RE: **Highland on Conway (Delmar Gardens III) SDP:** A Site Development Plan, Tree Stand Delineation, Tree Preservation Plan, Landscape Plan, Lighting Plan, and Architectural Elevations for a 5.292 acre tract of land zoned "PC" Planned Commercial District located on the north side of North Outer 40 Road, east of Chesterfield Parkway East.

Planning Commission Staff Report

Description: **Highland on Conway (Delmar Gardens III) SDP:** A Site Development Plan, Tree Stand Delineation, Tree Preservation Plan, Landscape Plan, Lighting Plan, and Architectural Elevations for a 5.292 acre tract of land zoned “PC” Planned Commercial District located on the north side of North Outer 40 Road, east of Chesterfield Parkway East.

Re: Delmar Gardens III

SITE SECTION A-A

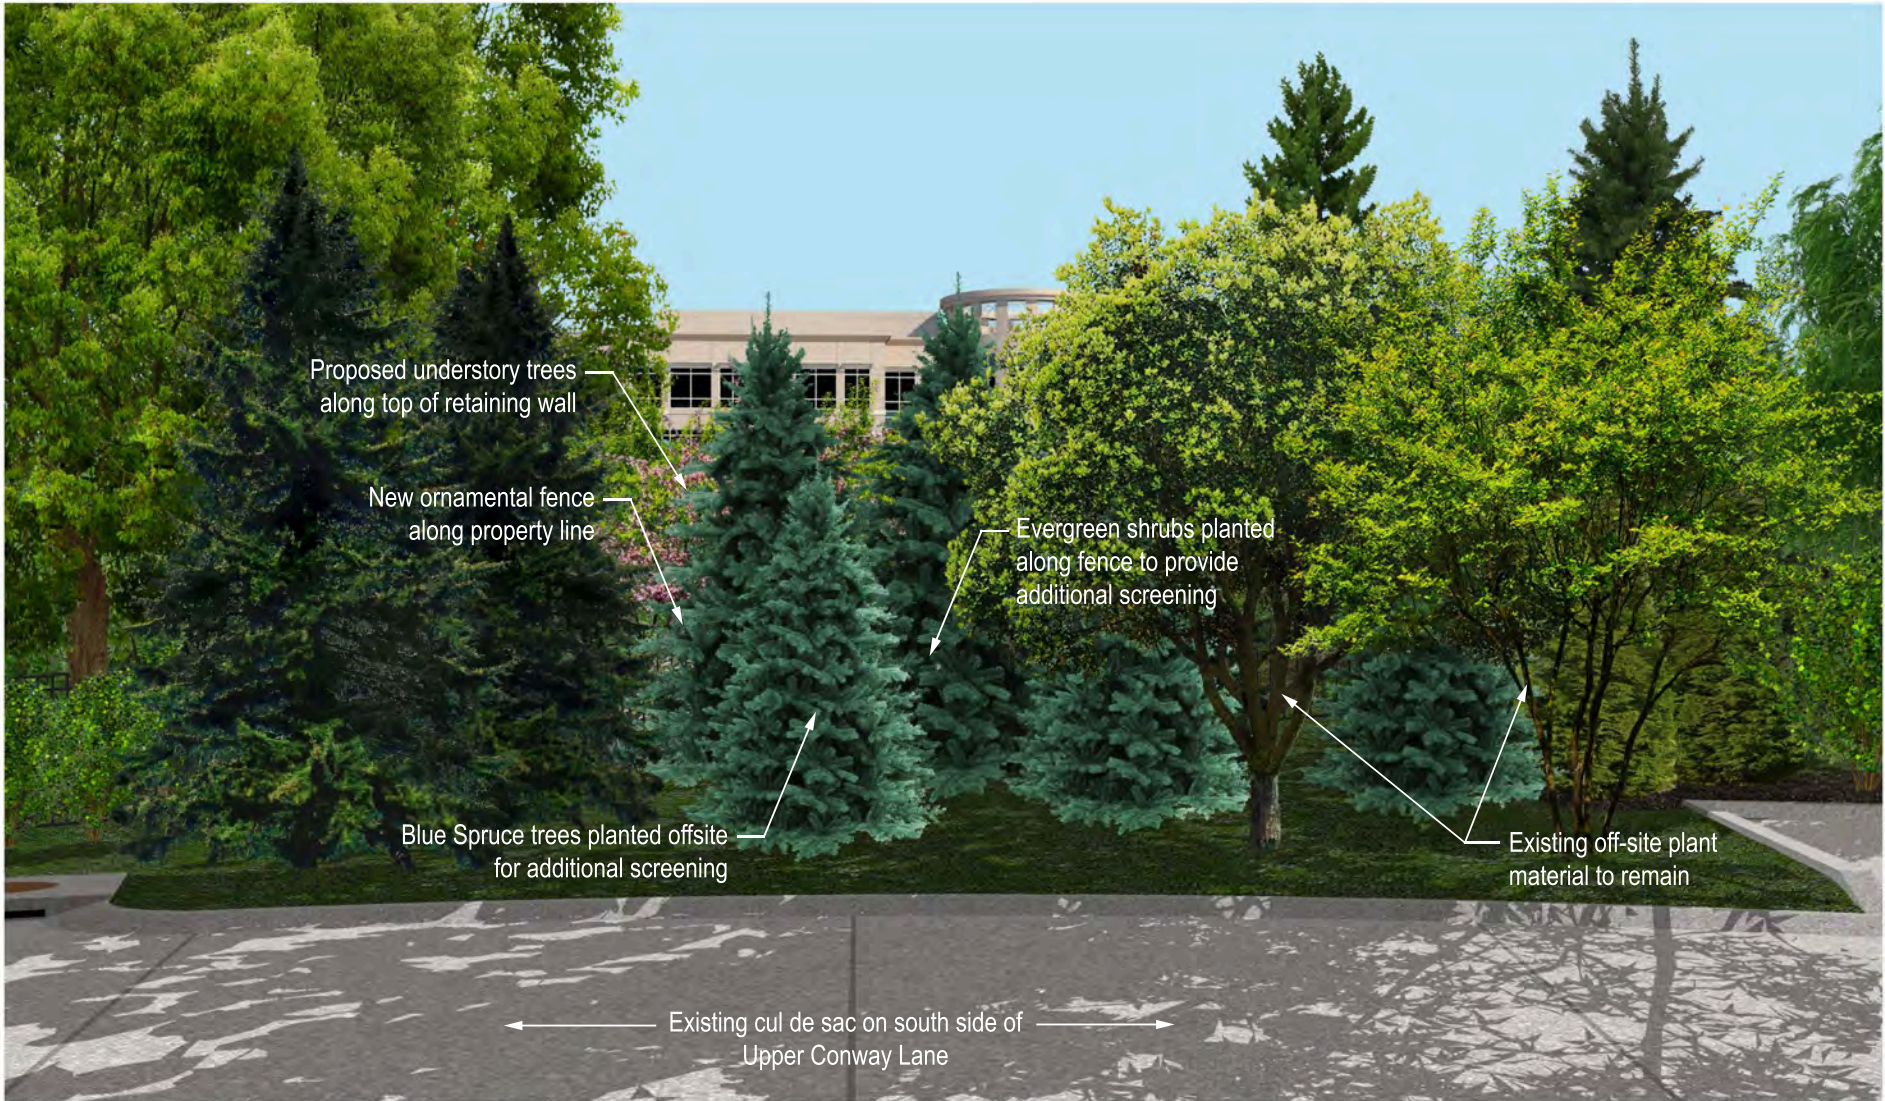
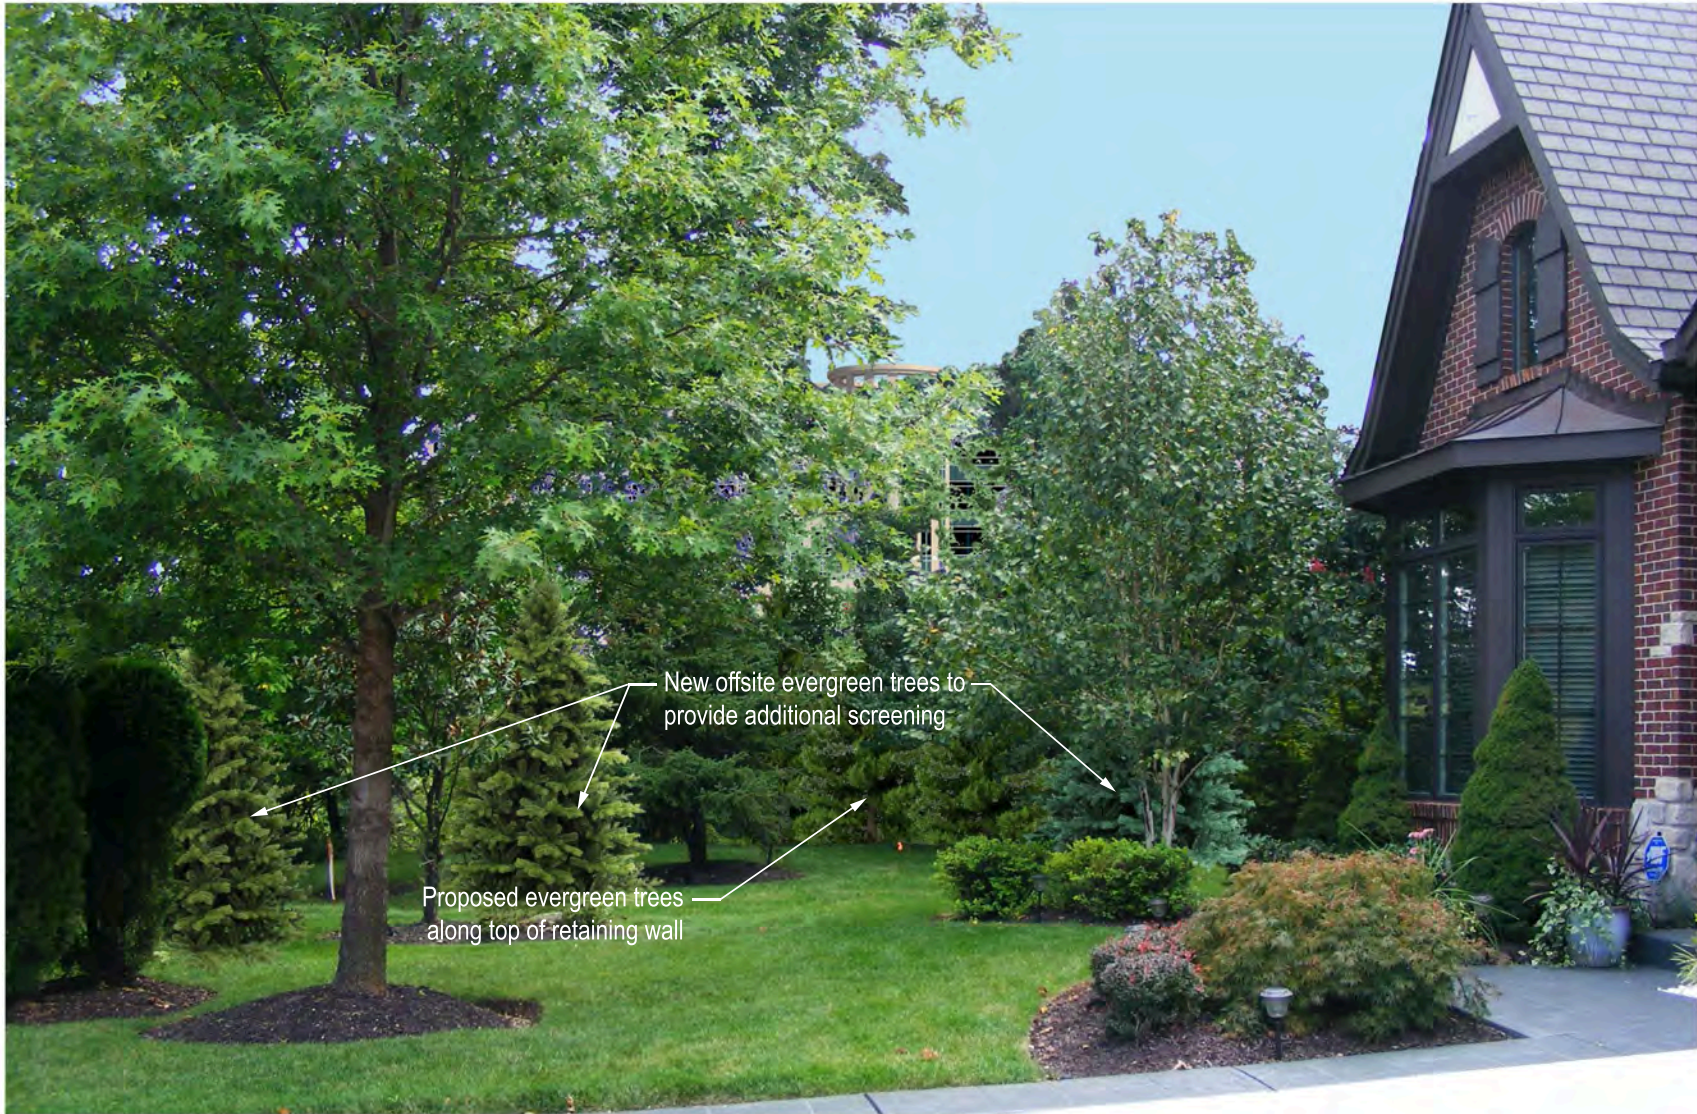
There were various questions regarding the proposed retaining wall and heights of the proposed buildings at the August 24, 2015 Planning Commission meeting. These have been addressed in

2) Possibility of using the garage wall as the retaining wall

Due to the existing grades, the garage parapet wall would need to be increased from 3.5' to a height of 14.5' in the western corner and would taper down to the current height of 3.5' as it moves to the east. This would create a significantly different and non-desired architectural appearance of the parking structure. The current proposal allows the developer to include landscaping between the garage and the retaining wall to help soften the view from the parking garage which would not be possible if the garage wall was also the retaining wall.

We have updated our site section to reflect the revised retaining wall design at the proposed parking structure.

GARAGE - SOUTH ELEVATION

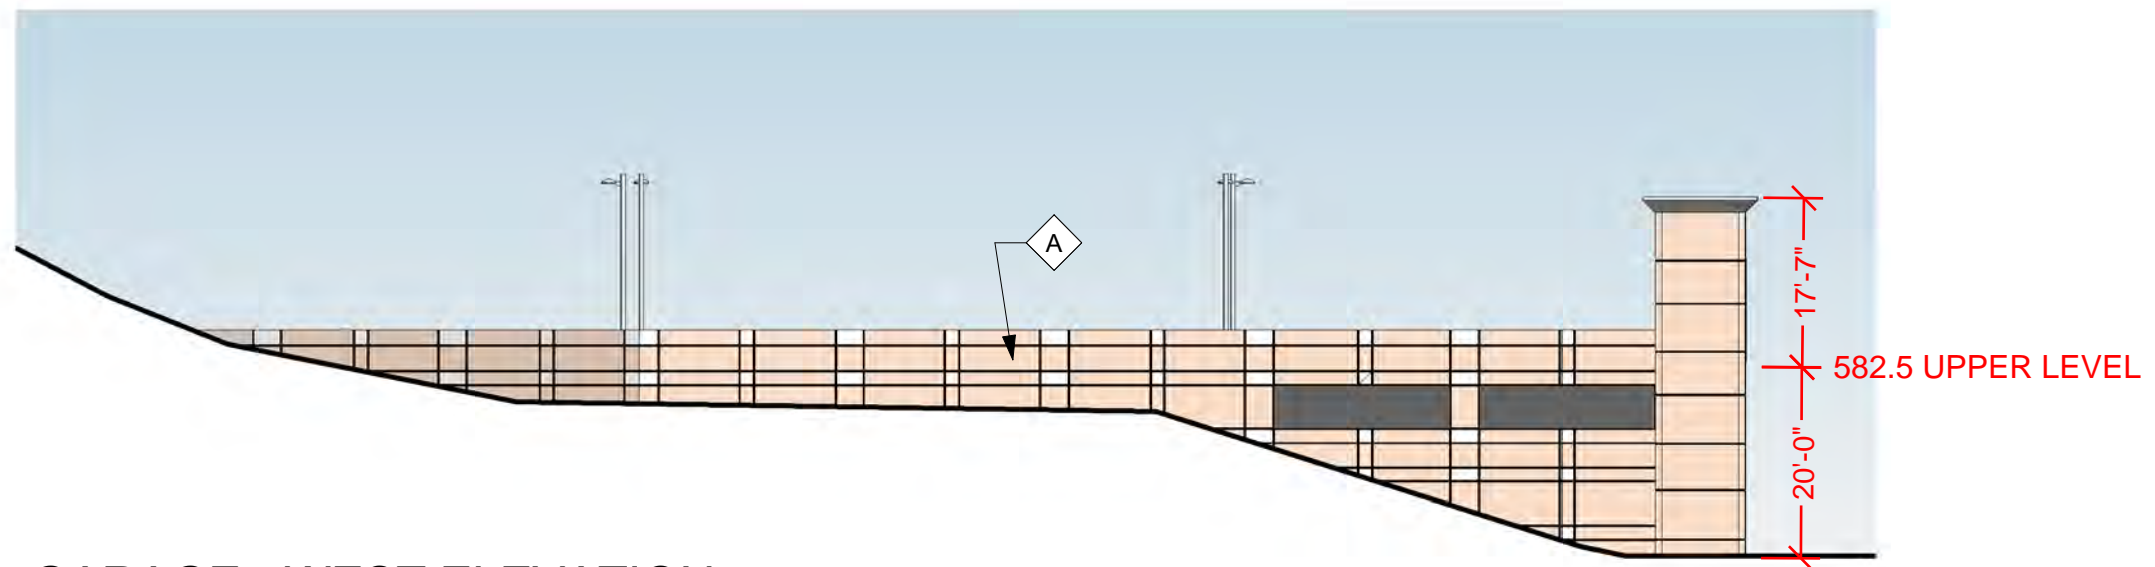
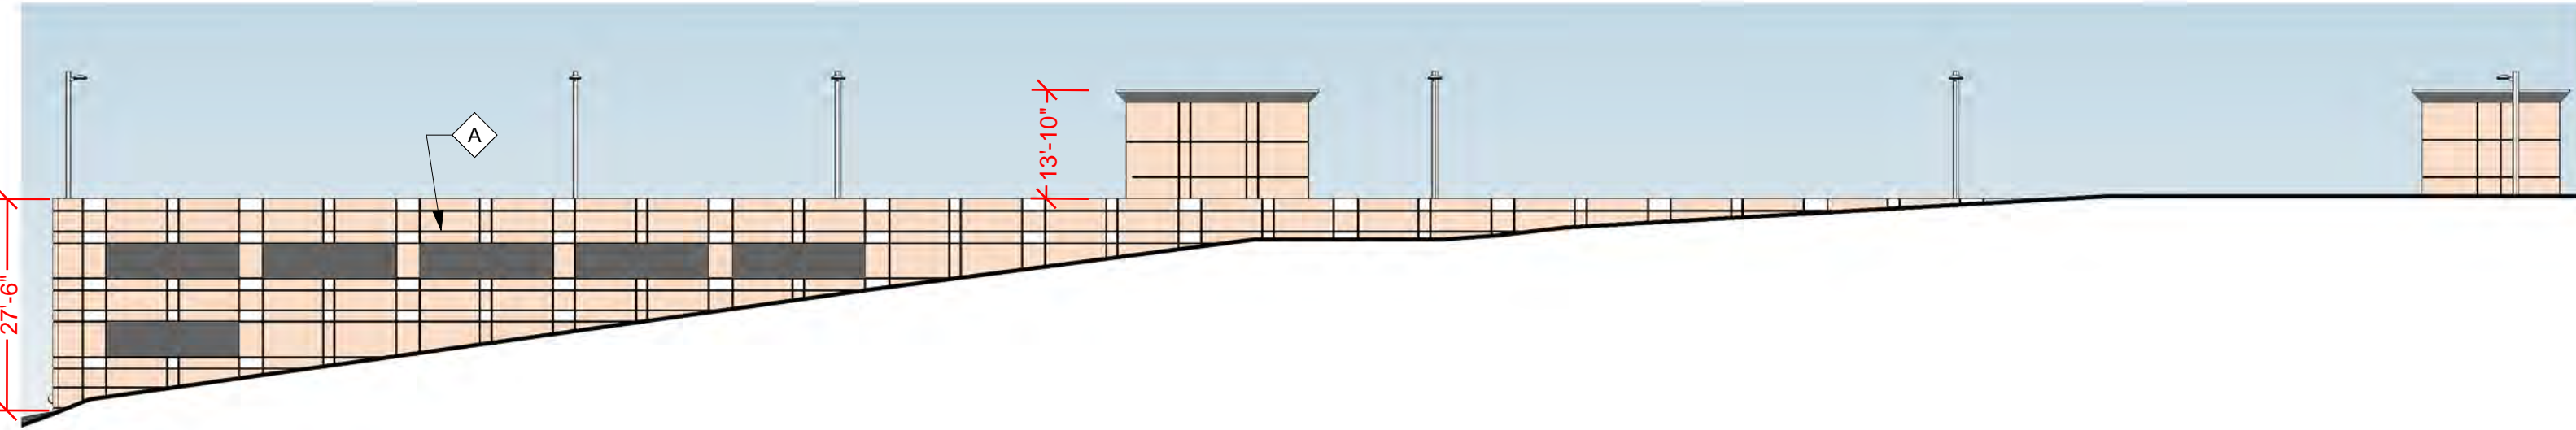
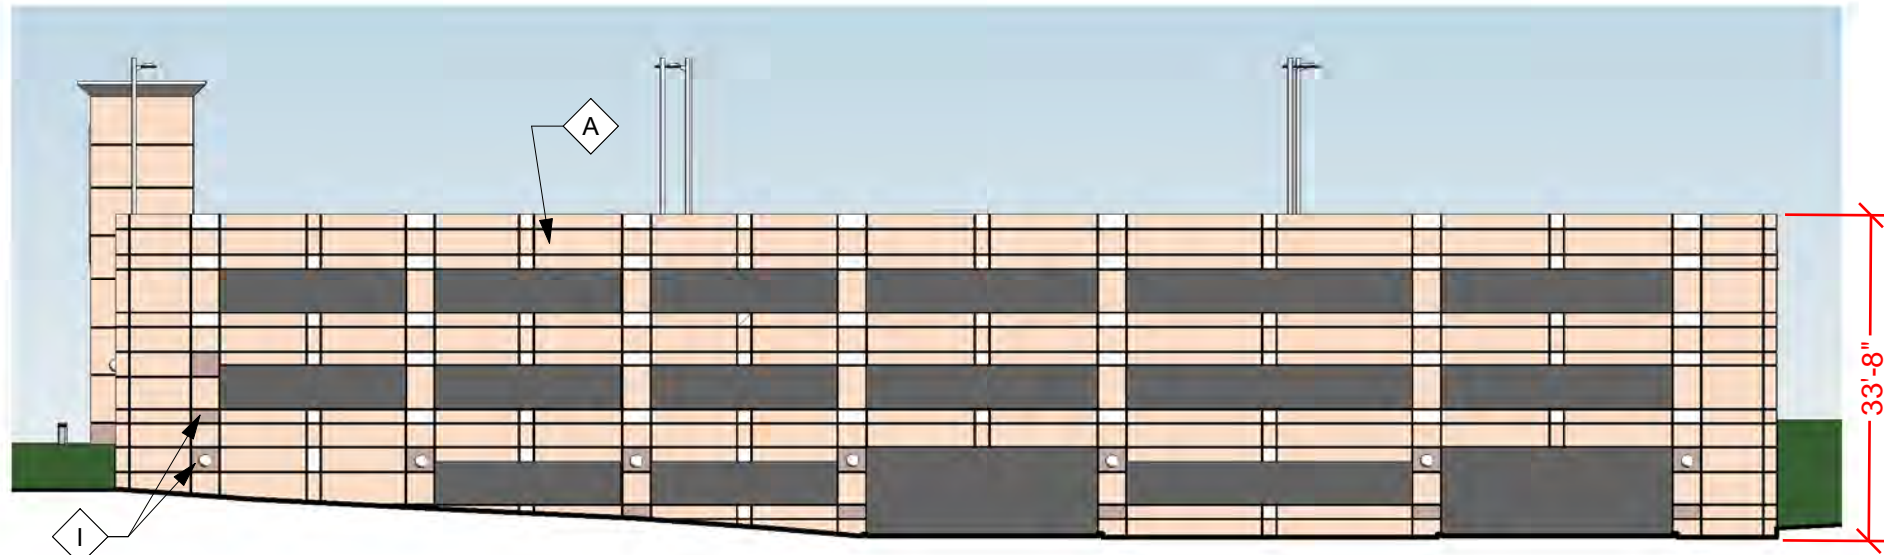
3) Parking structure stairwell enclosure height

Although the stairwells extend 14' above the parapet wall or 17' above the top parking level, they will only be 3.5' above the maximum height of the proposed retaining wall. The stairwells are also located on the south side of the parking structure approximately 200' from the northern property line. This horizontal separation will contribute to the lower visibility of these elements. Additionally, the applicant clarified that the proposed towers were designed to imitate the same size, scale, and proportions of the existing stair enclosures on the adjacent Delmar Gardens property.

Our proposed stairwell towers are the same height as the stairway enclosure constructed on the award-winning DGE I and II campus. Our intention for this new project is to construct a 'sister' building and parking structure to the existing Delmar Gardens campus. We are simply repeating the same size, scale and proportions of the current stair tower.

About 13' of the stair enclosure accommodates circulation, decorative lighting and overhead structure to enclose the staircase volume. Another 4' of the enclosure is the aesthetic cornice element consistent with the design of the adjacent office building to the south. (The ordinance sets the maximum height of the top parking level at 585. We are therefore 2.5' below the height limitation for the parking structure.)
